TO: Mercedes-Benz Dealer Principals, General Managers, Sales Managers, Service Managers, Parts Managers	FROM: Gregory Gunther, Department Manager, Vehicle Compliance and Analysis, Engineering Services
RE: Service Campaign Launch Notification Retrofit Damping on Front Axle and Replace Engine Lining MY22 EQS-Class (297 platform)	DATE: May 27, 2022

Campaign No. 2022050012, May 2022

Retrofit Damping on Front Axle and Replace Engine Lining

Figure 1

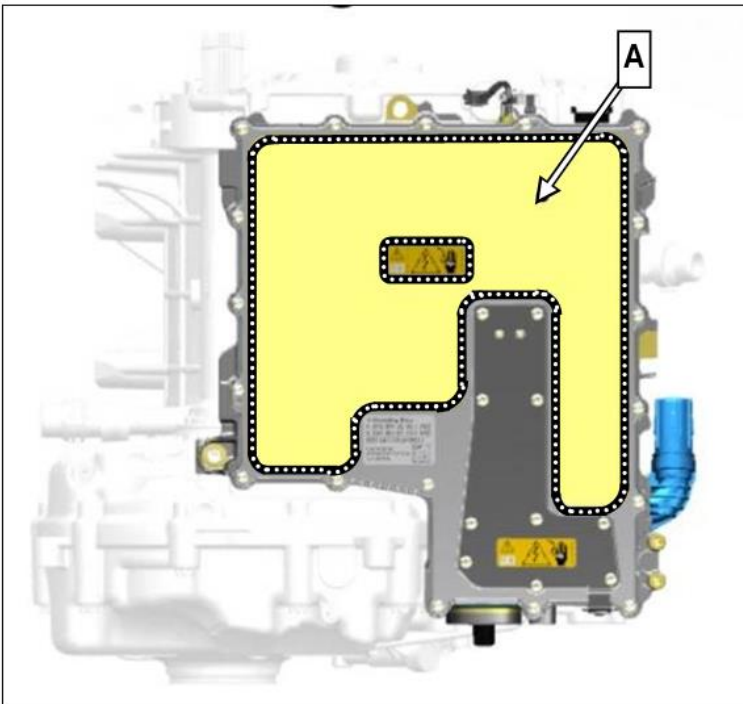
Mercedes-Benz AG ("MBAG"), the manufacturer of Mercedes-Benz, has determined that on certain MY 2022 EQS-Class (297 platform) vehicles, the damping on the front axle and rear engine compartment lining do not correspond to current specifications. Thus, it is possible the electronic drivetrain transmission may result in noise in the cabin.

1. Perform power disconnect of high-voltage on-board electrical system.
 For basic data, see AR47.70-P-1000EQS.
2. Remove rear engine compartment cover (**B, Figure 2**).
 For basic data, see AR61.20-P-1105EQS.
3. Retrofit damping (**A, Figure 1**) in area of power electronics control unit (N147/4) on front axle drive module.
 Before installing the damping, the surface of the power electronics on the front axle drive module must be cleaned.
4. Replace rear engine compartment cover (**B, Figure 2**).
